**PETITION NO:** SLUP- 11

**PROPOSED USE:** Suite Hotel

# SLUP-11-2016 GIS

### SLUP-11      VISION HOSPITALITY GROUP

2 NORTH ELEVATION

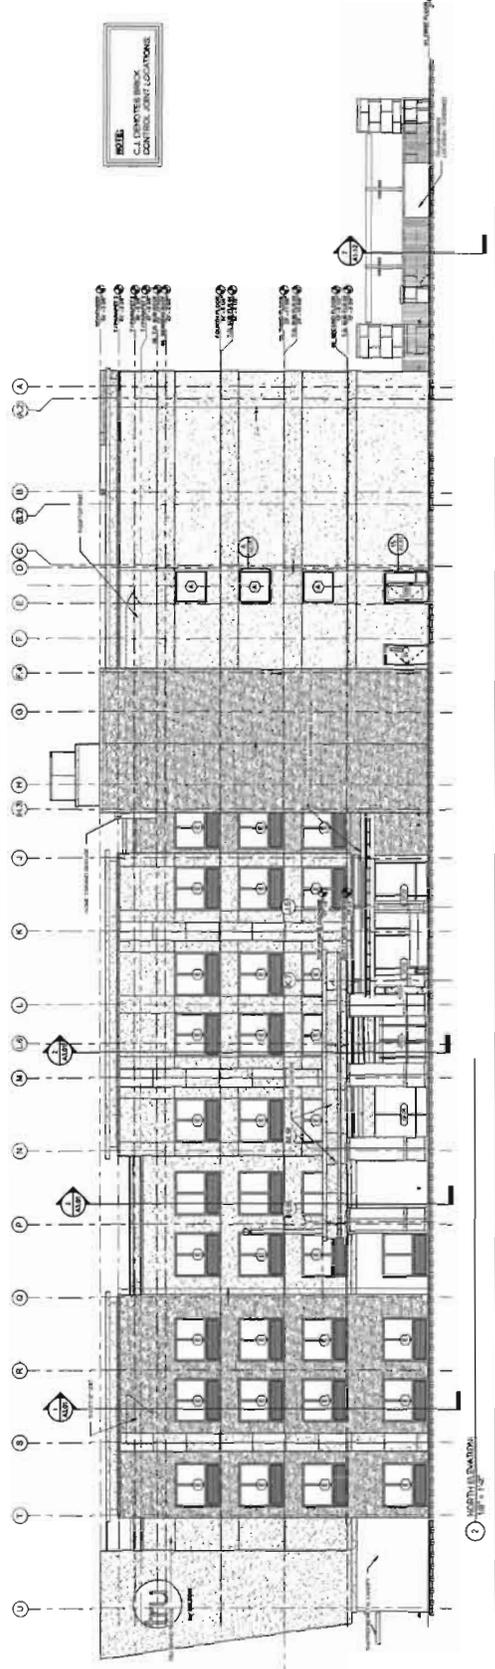
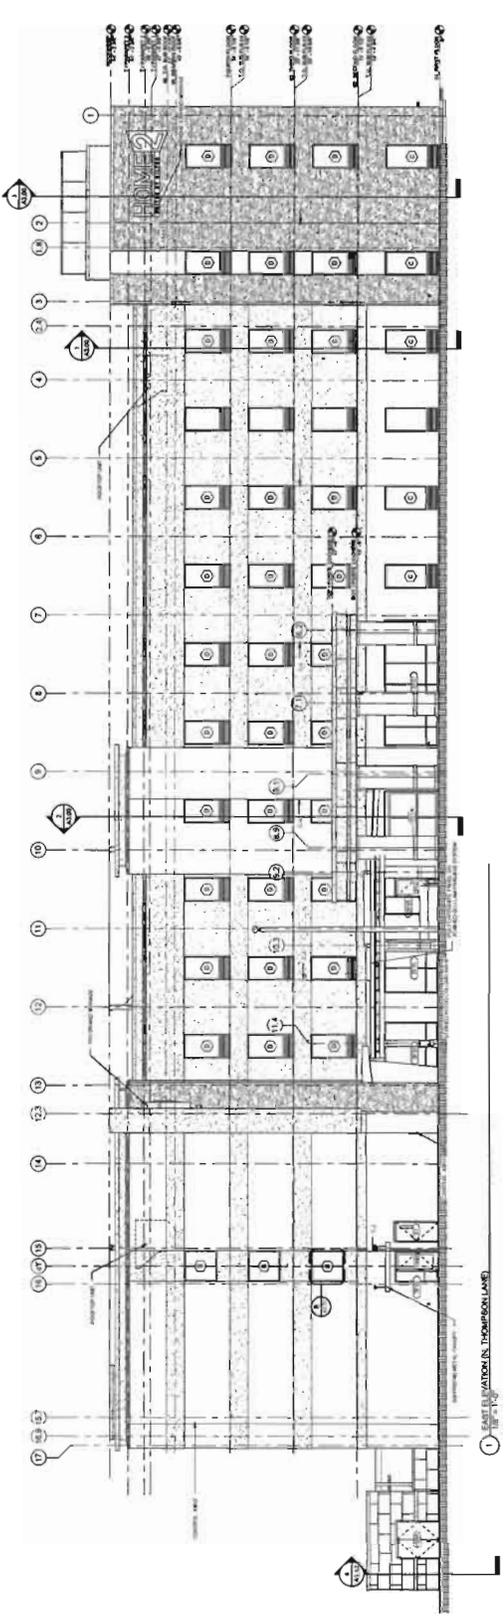
- 5) *"Architectural Style/design to be approved by the board of commissioners."* The building elevations are included for approval.
- 6) *"All buildings shall have a minimum roof pitch of a four in twelve as defined by applicable building codes"*. The building will have a minimally sloped roof with parapets instead of a gable style roof as referenced.

We also request flexibility on section 134-277 (7), which limits the maximum building height to 50 feet. While the main roof level is 45' high, the highest parapet is proposed to be 54'-3" high and there is an architectural feature that extends to 62'-4".

1. Waiver of the required number of parking spaces from 180 to 170 (waiving the 10 extra spaces for employees);
2. Waiver of the minimum four in 12 roof pitch to a minimally sloped roof with parapets instead of a gable style roof; and
3. Allowing the building height to reach 50 feet. The main roof level is 45-feet high, the highest parapet is proposed to be 54’-3” high and there is an architectural feature that extends to 62’-4”.
